RESPONSE TO COMMENTS**NPDES Permit Modification NH0001473****GSP Schiller LLC****Schiller Station****Portsmouth, NH 03801**

In accordance with the provisions of 40 CFR § 124.17, this document presents EPA's responses to comments received on the draft NPDES Permit Modification NH0001473 (the "Draft Permit Modification"). The Response to Comments explains and supports EPA's determinations that form the basis of the final permit modification (the "Final Permit Modification"). From October 4, 2022, through November 17, 2022, EPA solicited public comments on the Draft Permit Modification of NPDES permit NH0001473, issued on April 6, 2018, to discharge to, and withdraw cooling water from, the Piscataqua River.

EPA received comments from GSP Schiller (the Permittee) and joint comments from the Sierra Club and the Conservation Law Foundation on November 17, 2022.

Figure 1: Schiller Daily Percentage Operation (Spring-Fall, April 2016-June 2020)¹¹

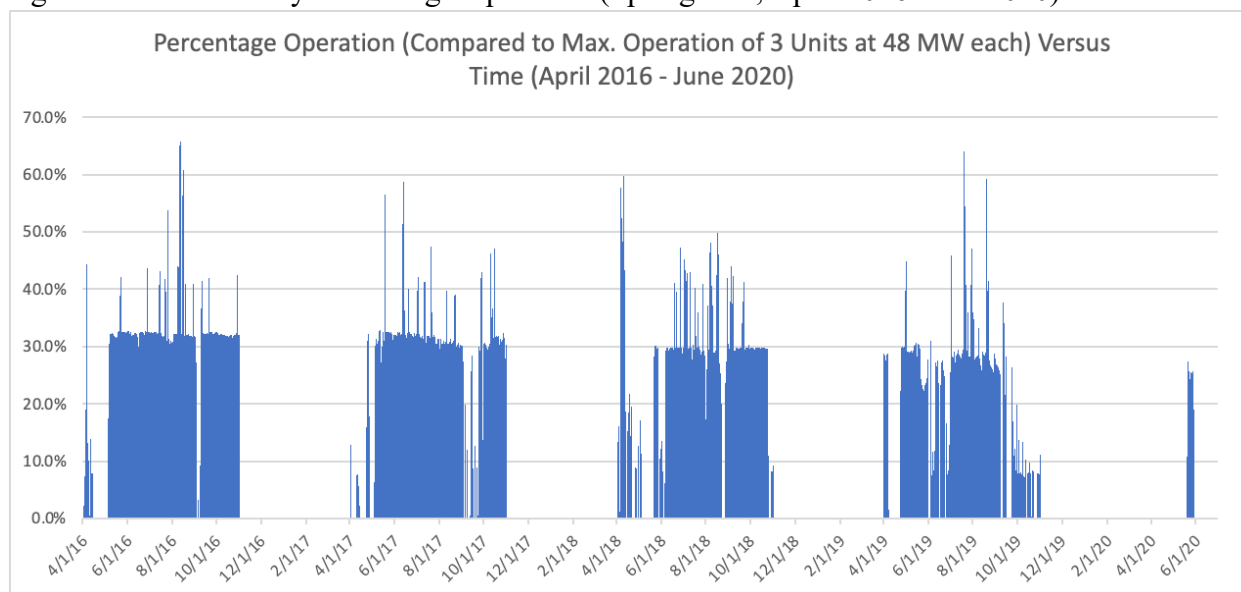
As was apparent to EPA before it finalized the 2018 NPDES permit, the overall capacity factor at Schiller Station is relatively low (even in the years preceding summer of 2020, when Schiller ceased operating at all). Indeed, Schiller's capacity factor in both 2016 and 2017 was well-below a third of overall capacity, with the two-year average for that period being just 29.8%. Nor does annual capacity factor at Schiller during this period mask particularly higher seasonal or even *daily* plant operations—during the months of April through October from 2016 through 2020, Schiller's generation was consistent with no more than just one unit operating on the vast majority of days it actually operated. As the data in Exhibit 1 - Schiller Operations Data 2016-2020 shows, very rarely during those months has Schiller historically operated at levels above 33% of capacity (and only rarely did days involve operations significantly above 33% capacity), meaning that Schiller's daily CWIS flows almost never exceed the limit EPA proposes in the draft Modification for April-October operations.

Indeed, daily operations above 33% capacity only amount to roughly 5% of overall days, meaning that the proposed 66% reduction in CWIS flows in the draft Modification would, at the very best, only reduce CWIS actual flows by 5% spread out over *five years*. Moreover, during the period examined there were hundreds of days involving much less than 33% capacity, meaning that EPA's proposed CWIS flow limits would allow *increases* in flow levels—and concomitant entrainment—on those days.

The comment opposes the Draft Modification on the basis that the proposed alternative for complying with the entrainment BTA will not result in significant changes in actual flows at Schiller Station and will not provide any reduction in entrainment. The comment supports its claim with a spreadsheet analysis¹⁰ comparing entrainment under the proposed flow limits to estimated entrainment if the Facility were to use wedgewire screens under recent operational flows (2016-2020). The comment essentially boils down to a claim that EPA errs in its estimation of comparably effective flow limits by considering the entrainment impacts of Schiller's cooling water intake structures at design flow and should instead base its decision solely on entrainment impacts at recent operational flows. The comment therefore mistakenly focusses on comparing entrainment estimated to occur at the proposed flow limits only to entrainment estimated to occur with wedgewire screens at recent operating levels. The comment, however, never explains the basis for its flawed premise and overlooks two critical facts—first, that, in the 2018 Final Permit, EPA grounded its decision establishing wedgewire screens as the entrainment BTA for Schiller Station's cooling water intake structures on estimates of entrainment *at design flow*, *see* Fact Sheet at 93-97, 105; 2018 Response to Comment at 293-94, and second, that the 2018 Final Permit authorizes the facility to operate *at design flow*, 2018 Final Permit Part I.A.2. For these reasons, EPA, in the Draft Modification, reasonably compared entrainment estimates under the flow limits to entrainment estimates with wedgewire screens *at design flow*.

Figure 2: Weekly Mean Entrainment Density (2020 Normandeau Report)¹⁸

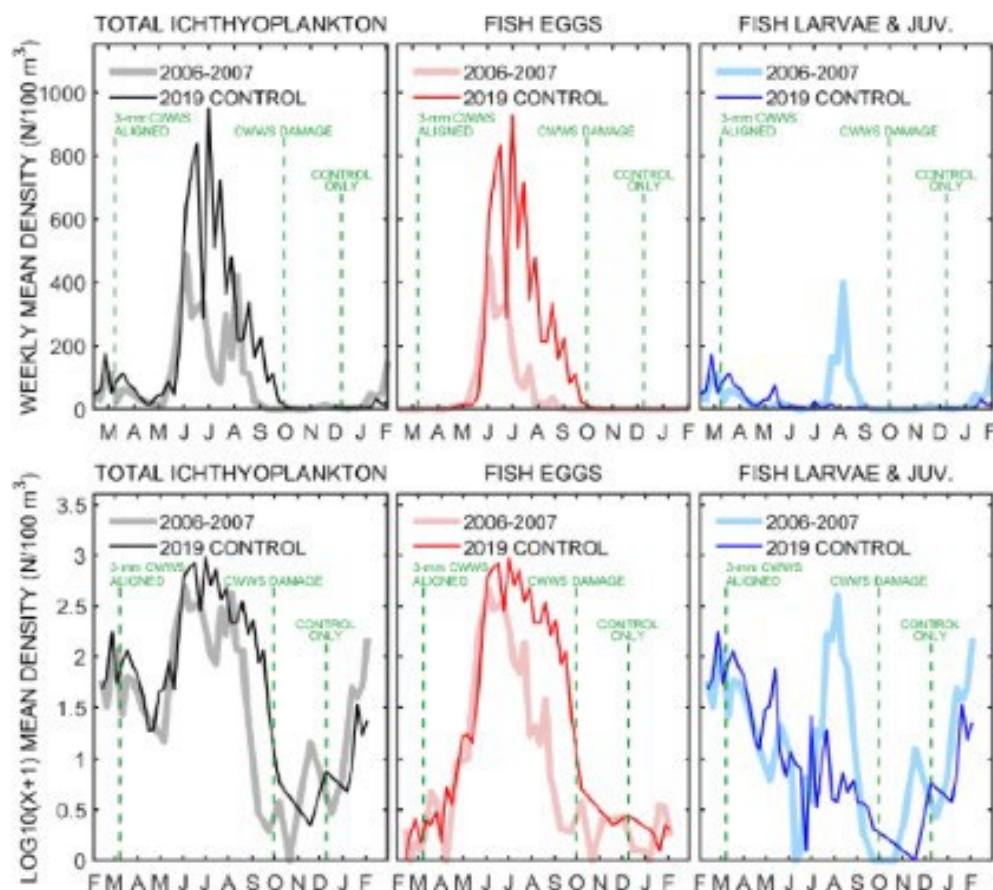
As an example of climate change and varying annual conditions shifting spawning timelines, Figure 11 of the 2020 Normandeau Report plots data from 2006-2007 as well as “2019 control” data. 2019 was a warmer year than 2006 and 2007, and there is a marked temporal shift in most of the plotted peaks in 2019 towards later months as compared to the earlier, cooler years.

Indeed, the 2020 Normandeau Report also does not support EPA’s proposed unconstrained CWIS flow limits and lack of BTA screens in December and January. As Figures 17 and 18 in that Report indicate, entrainment densities of eggs and larval and juvenile fish actually increased significantly in those months significantly with the preceding November and December. *See* 2020 Normandeau Report at 79-80. As such, reliance on seasonal CWIS flow limits to reduce harm commensurate with continuously-in-place screens is unsupported and inconsistent with the requirements of BTA.

Sierra Club references Figure 11 from the 2020 Normandeau Report (AR-499) to suggest that there is a “marked temporal shift in most of the plotted peaks in 2019 towards later months as compared to the earlier, cooler years.” The top three panels in Figure 11 (untransformed weekly mean densities) demonstrate that the interannual variability between sampling years is more pronounced than any seasonal shift. This variability is influenced by a number of factors including temperature. *See* AR-500, AR-502. Incubation time of fish eggs and larval growth rates are linked to temperature, and temperature changes during seasonal spawning periods can result in temporal shifts in ichthyoplankton densities. *See* AR-512; AR-513. While Sierra Club focusses on the untransformed data, EPA concludes that the log-transformed data in the bottom three panels in Figure 11 provide the more useful characterization because log transformation reduces influence of extreme values and, in this comparison, interannual variability.¹⁷ Sierra Club does not point to a specific example of temporal shifts in the figure, but EPA’s view of the information in Figure 11 is that the three bottom panels generally demonstrate fairly consistent patterns over the two periods for both eggs and for fish larvae and juveniles (with the exception of the August-September peak larval densities in 2006 which was not observed in 2019).¹⁸ Sierra Club also indicates that 2019 was a warmer year and suggests that temperature is the cause of the supposed temporal shifts “towards later months as compared to the earlier, cooler years.” However, temperature data collected during each of the entrainment studies (Figure B.2-1) demonstrate that temperatures between the two years were generally consistent and, where differences are observed (e.g., January and fall), that 2006 was warmer than 2019. EPA does not see evidence in the two studies that the 2019 study period was warmer than the 2006 study period or that there is a “marked temporal shift in most of the plotted peaks in 2019 towards later months as compared to the earlier, cooler years.”

As explained above, temperature impacts the timing of spawning and the duration of incubation. If, as Sierra Club suggests, 2019 was a warmer year than 2006, densities of early life stages in winter and spring would be expected to shift earlier in the year, not later, because warmer temperatures would shift spawning earlier and result in shorter incubation times. One change in egg density observed in Figure 11 is shift in peak egg density from late May and early June in 2006 to July in 2019. Regardless of whether the shift in egg density was related to later spawning or longer incubation periods during the cooler winter, the proposed flow limit in the Draft Modification for the period from April through October would be in effect and provide entrainment protection for both peaks. Another possible change in larval density in Figure 11 is a shift in the presence of eggs and larvae during fall from November in 2006 to December in 2007. Fall spawning is often triggered by a drop in temperature and a warmer fall could shift the timing of fall spawning later in the year; however, the temperature in Fall 2019 was cooler than in 2006. If temperature was related to the shift in early life stages in 2019, EPA would expect that the presence would increase earlier, not later in the season. The data in Figure 11 of the 2020 Normandeau Report (AR-499) do not provide sufficient support for Sierra Club’s argument that there are “marked temporal shift in most of the plotted peaks in 2019 towards later months as compared to the earlier, cooler years.”

Figure B.2-2. Weekly mean entrainment density and $\text{Log}_{10}(x + 1)$ transformed weekly mean entrainment density of eggs and larvae and juveniles at the existing cooling water intake structure (CWIS) for Units 5 and 6 ("Existing CWIS (Control)"). AR-499 Figures 17 and 18.

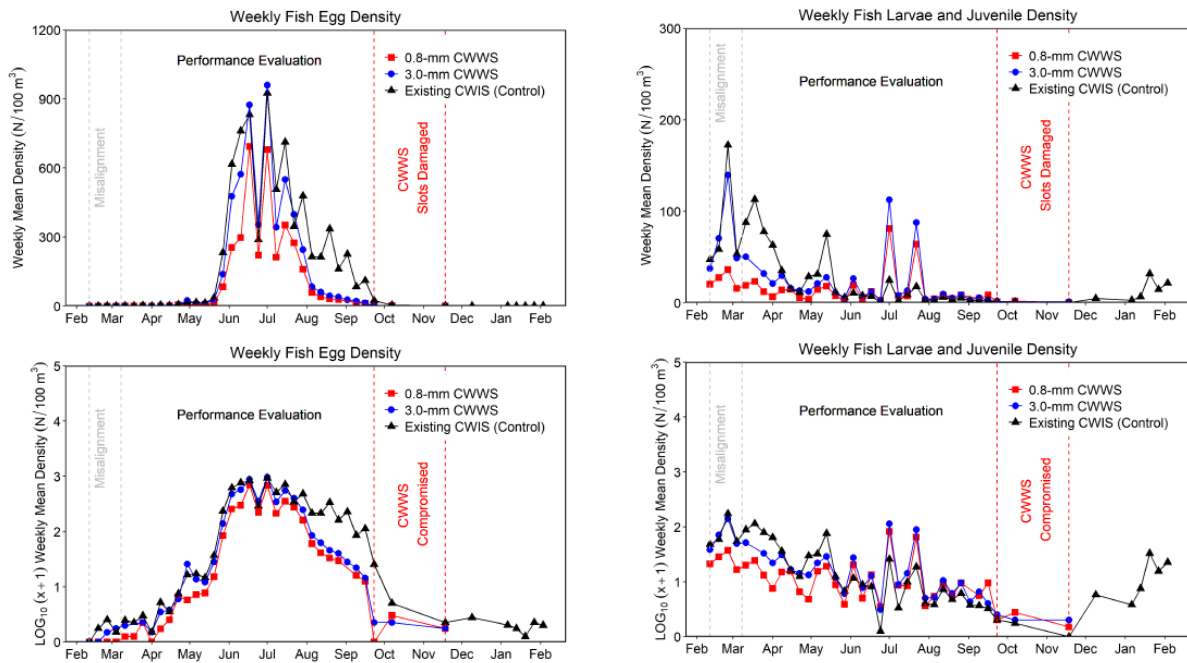
The Draft Modification proposed an average monthly flow limit at 66% of capacity for the months of February and March to provide comparable protection as wedgewire screens for early life stages of commercially, recreationally, and/or ecologically important species present in late winter and early spring, including Atlantic cod and American sand lance. The comment asserts that the lack of seasonal CWIS flow limits in December and January would not provide entrainment protection commensurate with continuously-in-place screens and references for support Figures 17 and 18 of the 2020 Normandeau Report (AR-499 at 79-80), which it claims demonstrate that densities of early life stages increased in December and January as compared to November. EPA agrees in part. Figure 17 demonstrates that in 2019, weekly mean *egg* density (and Log_{10} weekly mean density) decreased in October (as compared to the previous month) and remained relatively low for the rest of the year.¹⁹ Figure 18, however, demonstrates that in 2019, weekly mean density of *larvae and juveniles* began increasing in December (as compared to the previous month) and continued increasing into February and March. In addition, Figure 22 of the 2020 Normandeau Report (AR-499 at 84) illustrates that three of the top four larvae and juvenile species at the existing CWIS are winter spawners (American sand lance, grubby, and rock gunnel). While the Report does not include species-specific data for the months of November through February, Figure 22 does reveal relatively high weekly mean densities in March, suggesting that larvae are likely also abundant in the preceding months. Furthermore, Figure 11 of the 2020 Normandeau Report (AR-499 at 37), which Sierra Club references earlier in its comment, also indicates that the presence of larval and juvenile fish began increasing in December into January in both 2006-2007 and 2019. Taken together, Figures 11, 18, and 22 in the 2020 Normandeau Report (reproduced below as Figures B.2-2 and B.2-3) support Sierra

Club's argument, and convince EPA, that densities of fish larvae increase in November and are likely abundant in December and January as well as February and March.

larval abundance observed over decades further support establishing flow limits to provide comparable entrainment control for winter spawners from November through January as wedgewire screens would.
